# UNITED STATES PATENT AND TRADEMARK OFFICE

APPLICATION NO.	FILING DATE	FIRST NAMED INVENTOR	ATTORNEY DOCKET NO.	CONFIRMATION NO.
10/719,300	11/21/2003	Paul Masami Aoki	D/A 1441	2108
7590	06/13/2006		EXAMINER	
Charles A. Rattner Apt. 7 240 Wardwell St Stamford, CT 06902-5254			NGUYEN, KEVIN M	
			ART UNIT	PAPER NUMBER
			2629

<b>Office Action Summary</b>	<b>Application No.</b>	<b>Applicant(s)</b>	
	10/719,300	AOKI ET AL.	
	<b>Examiner</b>	<b>Art Unit</b>	
	Kevin M. Nguyen	2629

**DETAILED ACTION**

**FIG. 2**

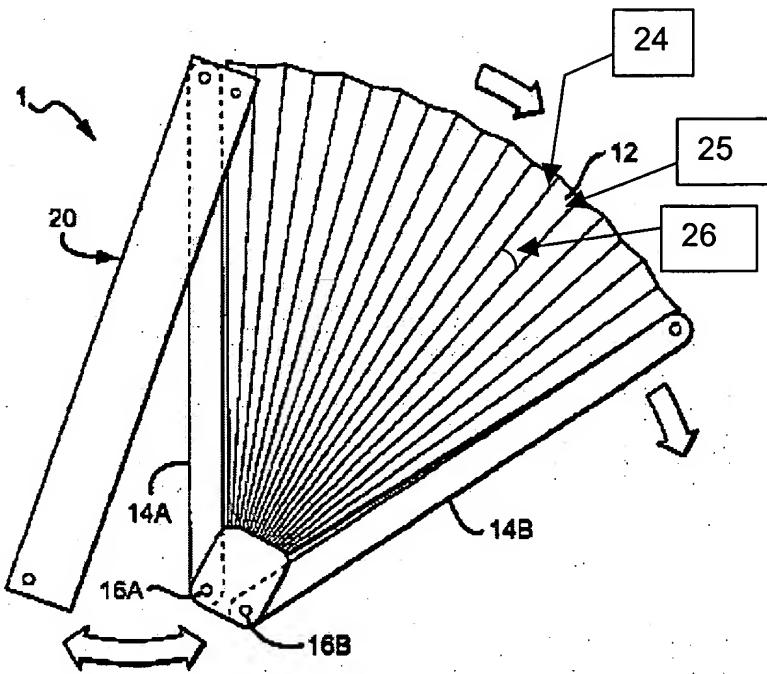
3. As to claim 1, DuBois teaches a fan-shaped display between an expanded configuration with a greater visible area and a collapsed configuration with a smaller visible area [see Figs. 1 and 2], the collapsible display comprising:

at least three collapsible sections [at least three folded display portions 12, Fig. 2], including at least one display section [it is noted that the folded display portions 12 also be made luminous by incorporating LED(s) display device or other devices, see col. 4, lines 1-2], coupled such that when the collapsible display is in the expanded configuration [when the fan-shaped display is unfolded, see Fig. 4], each of the collapsible sections [12] has a first end [24<sup>i</sup>] adjacent to another of the collapsible sections [12], the adjacent ends substantially aligned along an axis each display section [12] further has a second end [25<sup>i</sup>] that is substantially opposite to the first end [24<sup>i</sup>] and substantially oblique relative to the first end [two line segments, e.g., the combination of

the first end [24] and the second end [25] forms an acute angle, see Fig. 2, col. 3, lines 9-44 for further details of the explanation].

4. As to claim 2, DuBois further teaches the collapsible display further comprising a pivot [16A, Fig. 2] to which each display sections [12] is connected and about which each display section [12] can rotate [see col. 3, lines 30-44 for details of the operation].

7. As to claim 5, DuBois further teaches comprising a hinge element [24<sup>i</sup>, Fig. 2] for enabling the display sections [12] to rotate on an axis; two opposing panels [12]; an additional hinge element [25<sup>i</sup>, Fig. 2] for connecting adjacent sides of the two opposing panels and further for allowing the two opposing panels to rotate between an open position and a closed position, wherein the display sections [12] are coupled to the two opposing panels such that the display sections [12] are collapsed when the two opposing panels are in the closed position and the display sections are expanded when the two opposing panels are in the open position [see col. 3, lines 9-44 for further details of operation].

15. As to claim 18, DuBois further teaches comprising two opposing panels [two display sections 12, Fig. 2]; and a hinge element [an axis 24 coincide with the hinge, Fig. 2] for connecting adjacent sides of the two opposing panels and further for allowing the two opposing panels to rotate between an open position and a closed position, wherein the flexible display membrane [12] is secured to the two opposing panels at a plurality of positions such that the at least one display section is collapsed when the two opposing panels are in the closed position and the at least one display section is expanded when the two opposing panels are in the open position [the fan-shaped display device is in the closed and open positions, see Figs. 1-7, cols. 3 and 4, for further details of the operation].

22. As to claim 27, DuBois further teaches comprising: two opposing panels [a left and right display section 12 are symmetric to an axis 24, Fig. 2]; a hinge [24] for connecting adjacent sides of the two opposing panels [12] for allowing the two opposing panels [12] to rotate between an open position and a closed position; and a section of the display membrane [12] connected to at least one of the opposing panels, wherein the section [12] is deformed when the two opposing panels are in the closed position and the section is unfolded when the two opposing panels are in the open position to

unfolding a pair of opposing hinged panel sections [two axes 24 and 25 coincide with the hinge, see Fig. 2], at least one of the hinged [24] panel sections [12] connected to a section of a display membrane that is unfolded in an opposite position from the pair
